A G E N D A

Architectural Review Board

April 26, 2016

PLANNING CONTROLS DIVISION

729 Felder Avenue

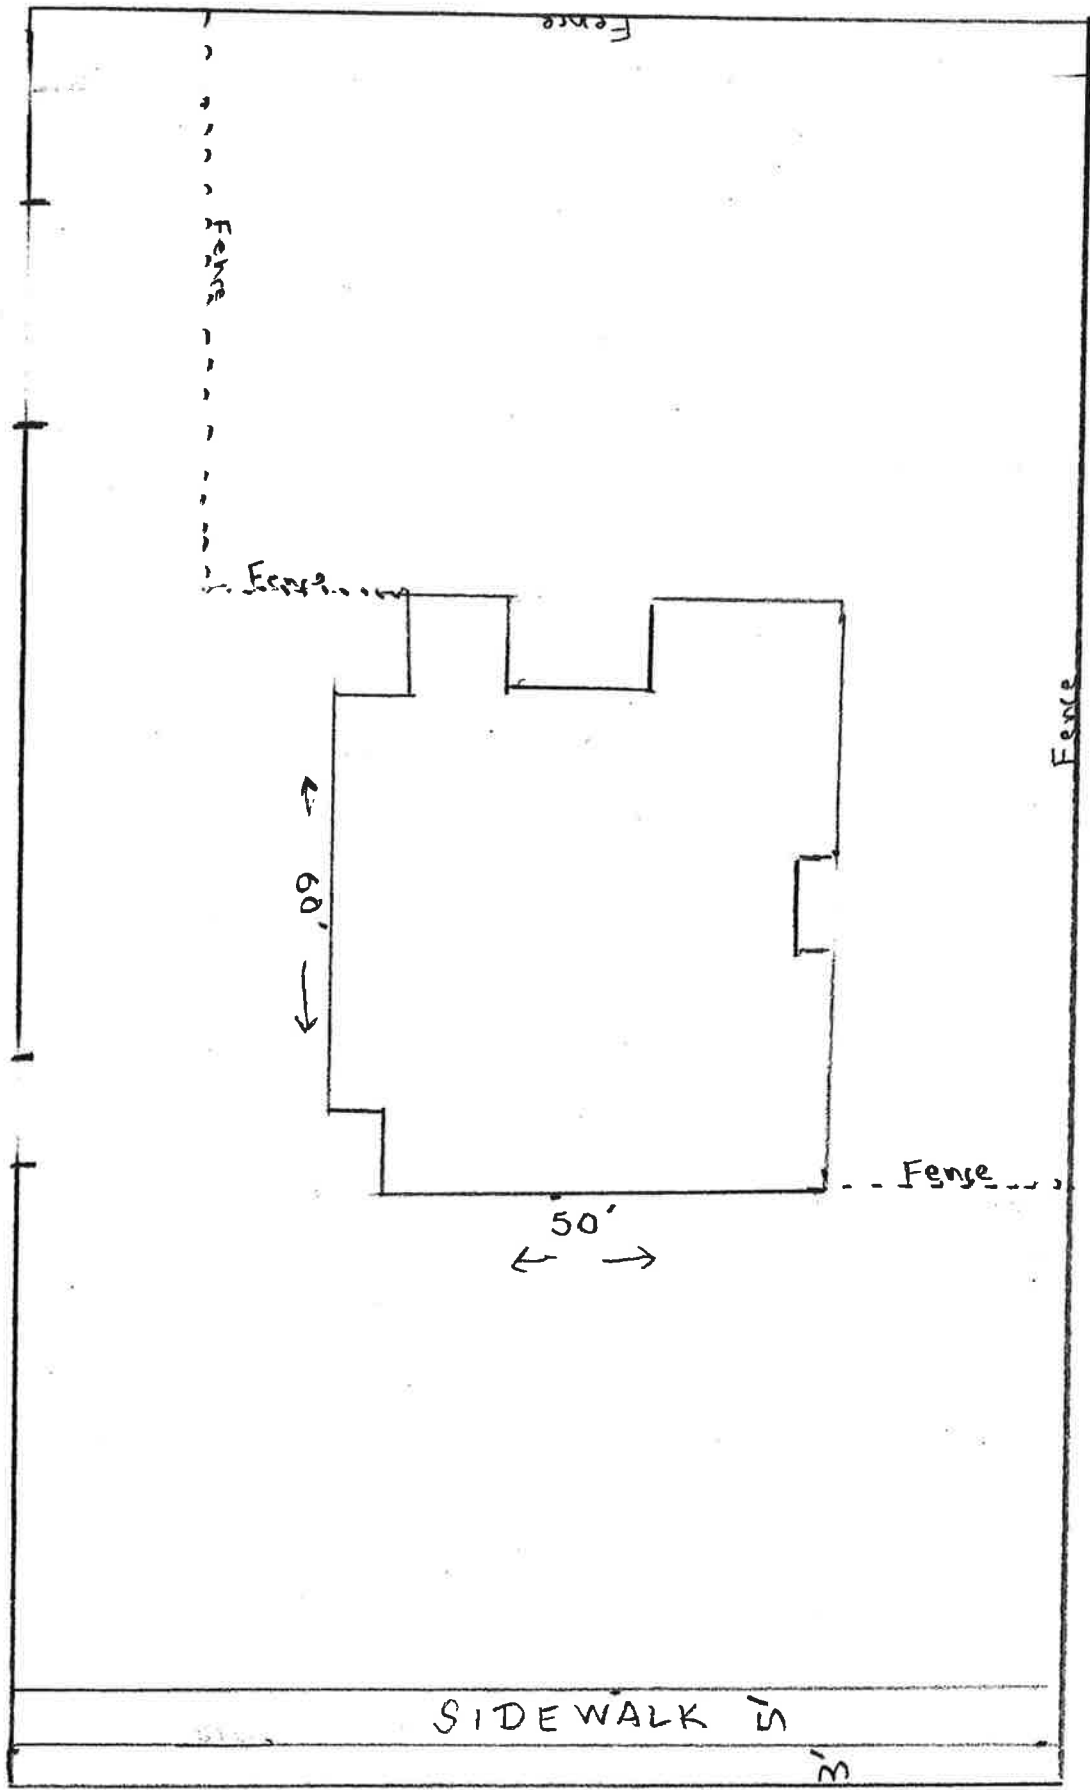
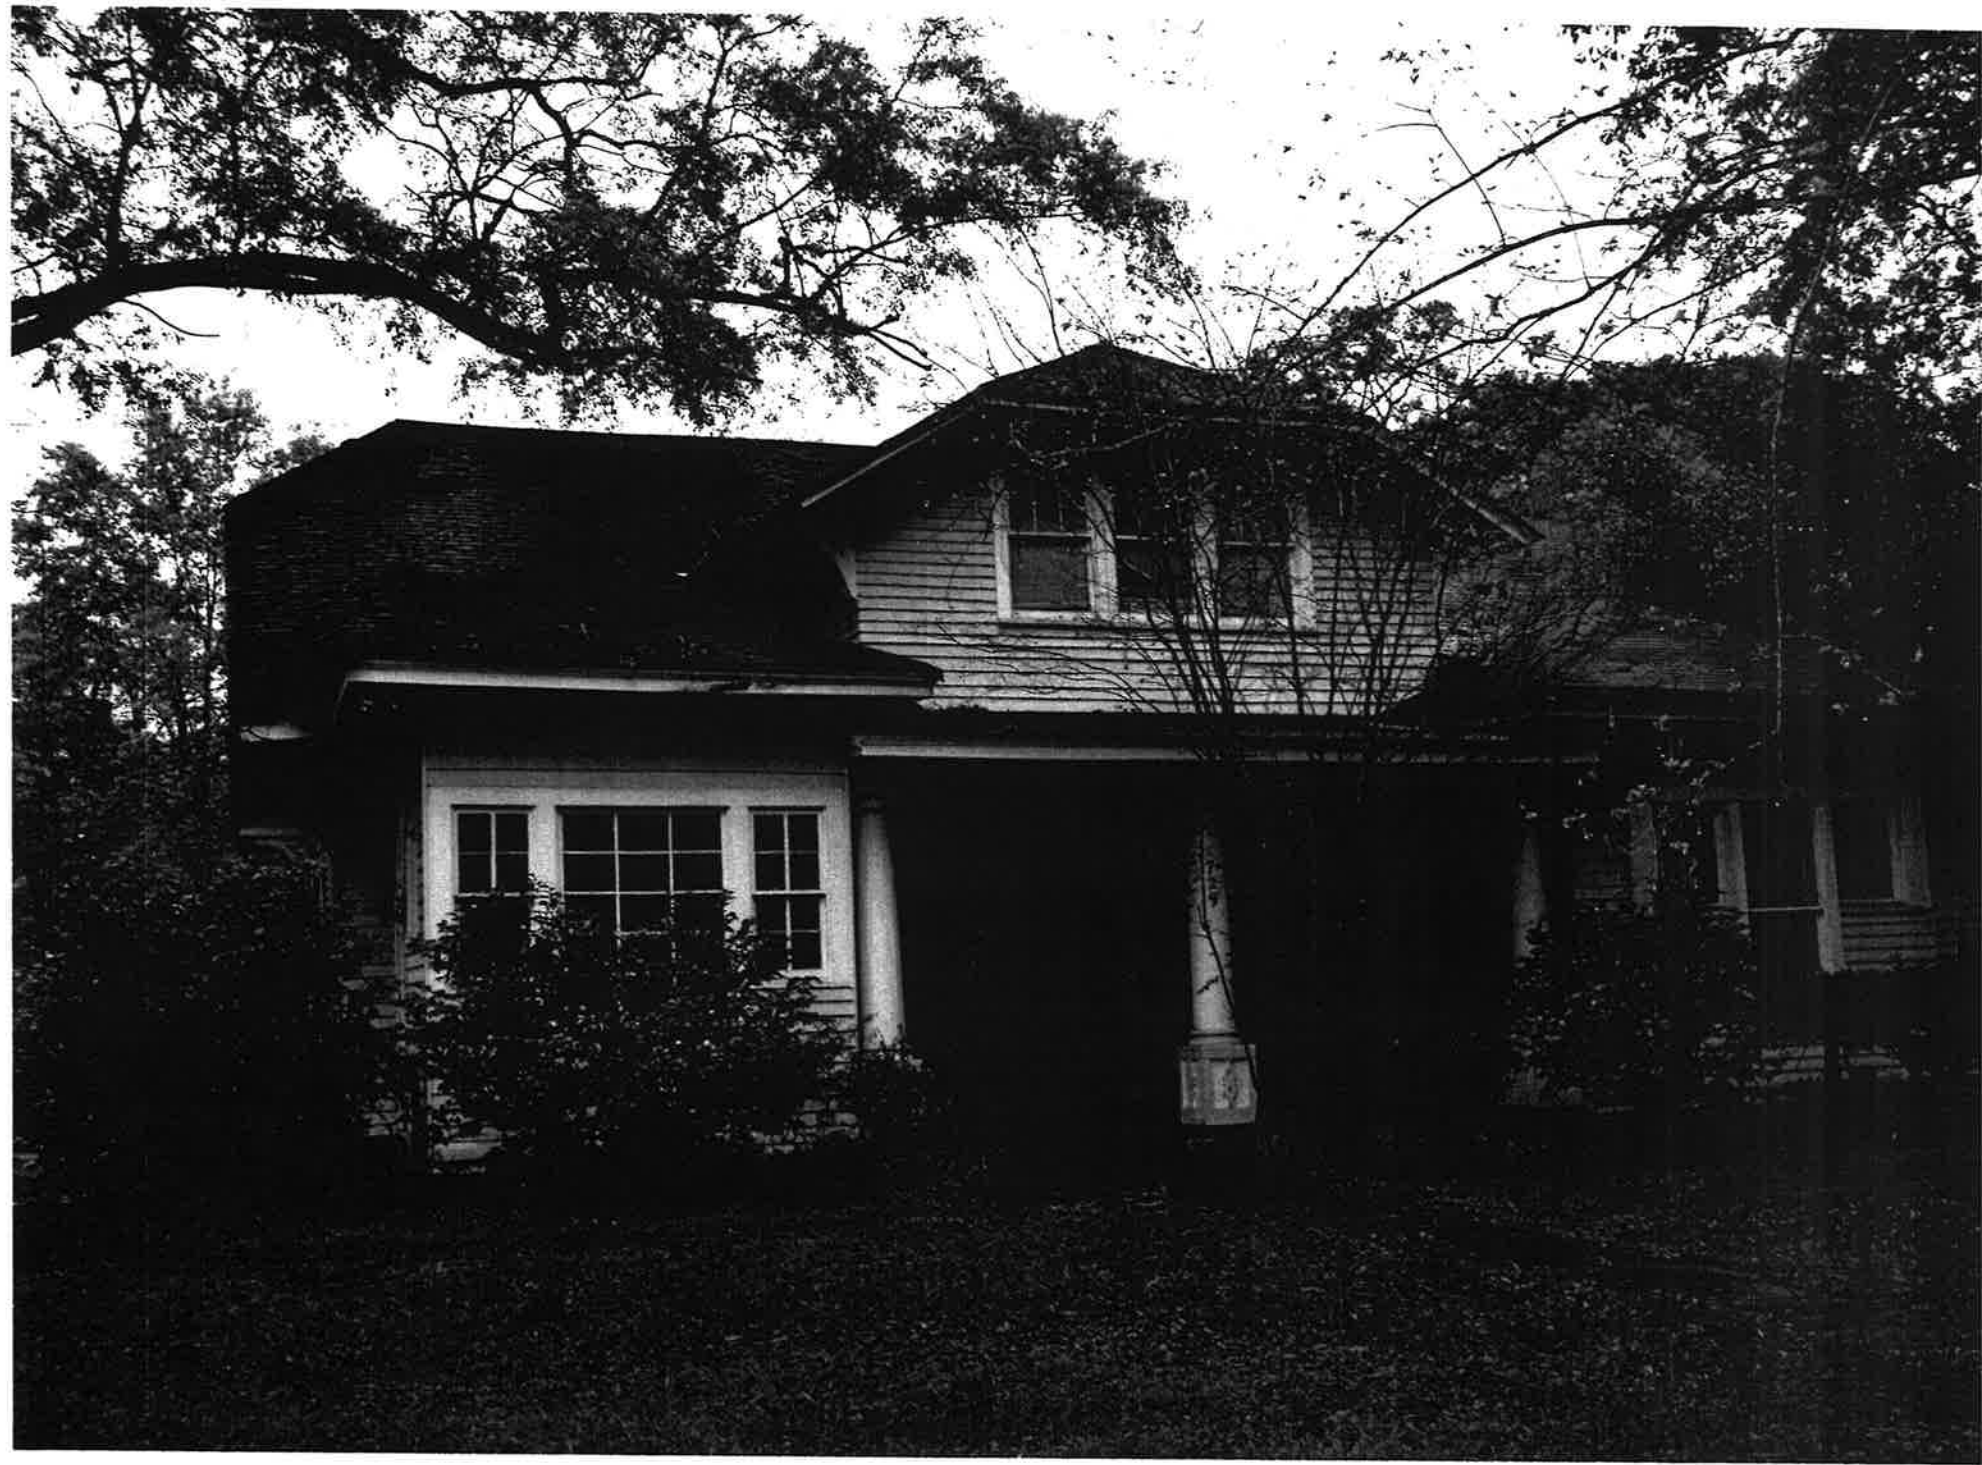
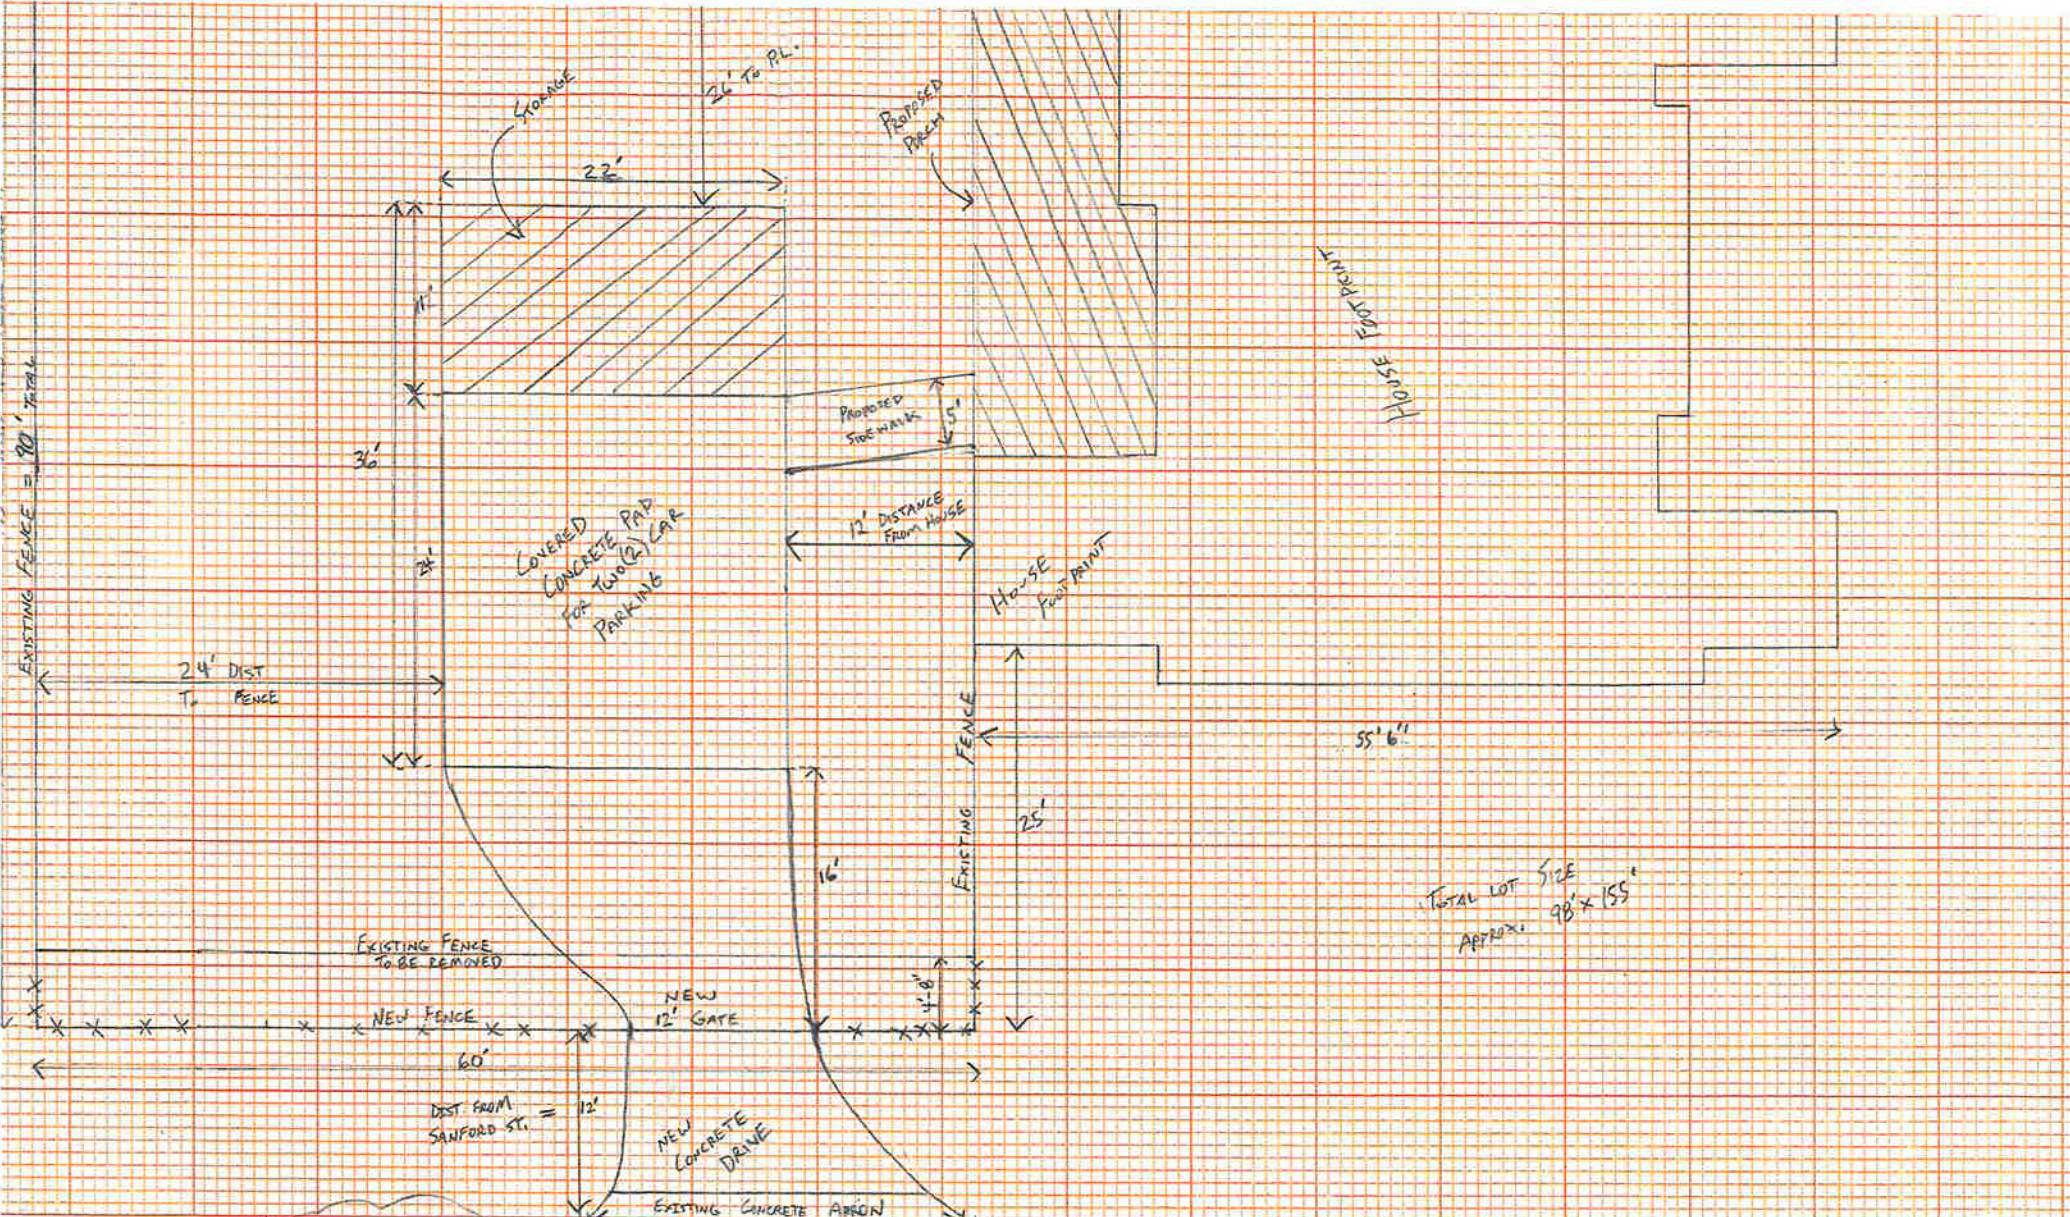
- Construct a 22'x36' carport with a gable roof and round columns as illustrated. The size and location is subject to review by the Board of Adjustment. The carport will have lap siding, and Pewter Gray architectural tab shingles.
- Relocate and replace an existing 6' wood privacy fence on the Sanford Street, and install a metal driveway gate (moving the fence closer to the street is subject to review by the Board of Adjustment. Because the location may not allow a car to fully pull in off the street before encountering an obstacle, the carport may need to move 5' further east than shown on the site plan).
- Pour a concrete driveway between the existing concrete apron on Sanford Street at the street and the new carport. The drive will be 12' wide at the gate and widen to 22' at the front of the carport (the full carport width).

- This is a corner lot.
- Because a variance is required for the fence and the garage, if the ARB approves the petition, staff recommends the Board approve it as submitted, and with a 5' shift to the east of the garage should the variance for the fence not be granted so the petitioner does not have to return to the Board.
- The Board has approved carport/accessory structures that were compatible with the style of the house, and appropriately scaled to the house.

2441 Agnew Street

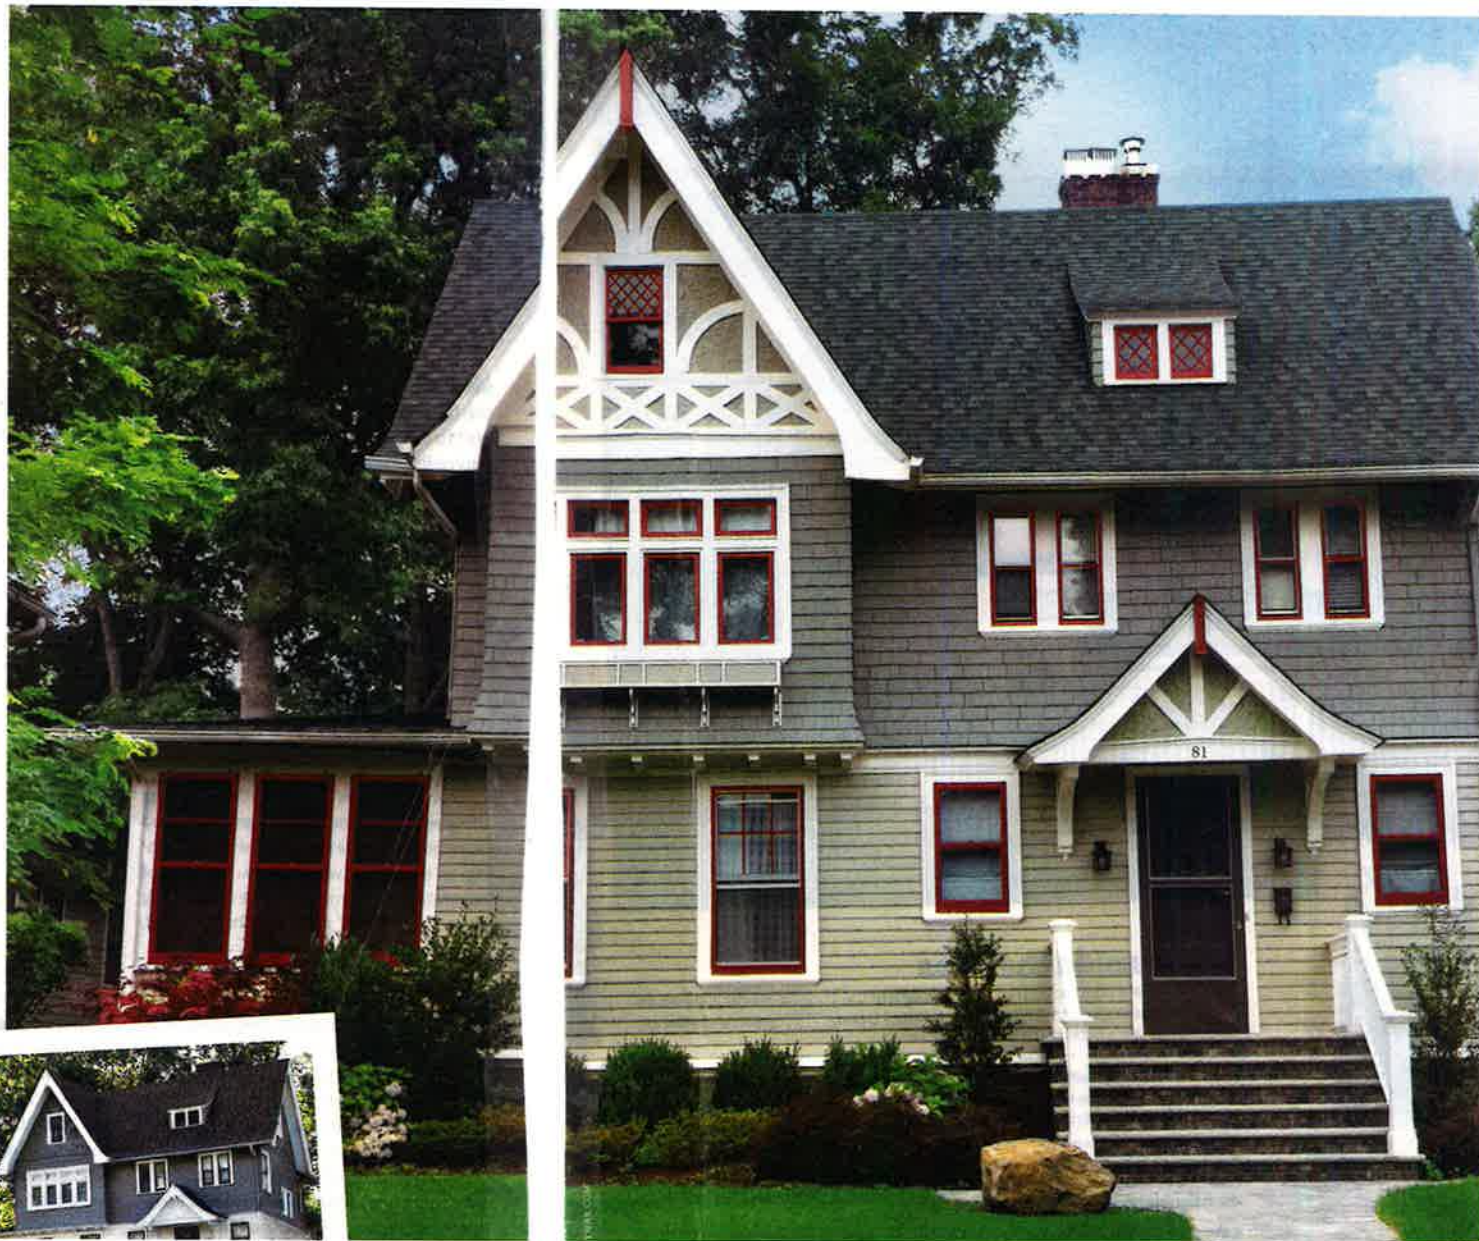
REMARKS: The petitioner is requesting permission to paint window sashes Behr Rumors MQ1-15d, which is a deeper maroon shade than photographed. A sample will be provided at the meeting.

- A stop work order was given to the painter on March 7, 2016, at which time only 2 ½ of the front windows had been painted. The remaining front windows were painted after the stop work notice was issued.
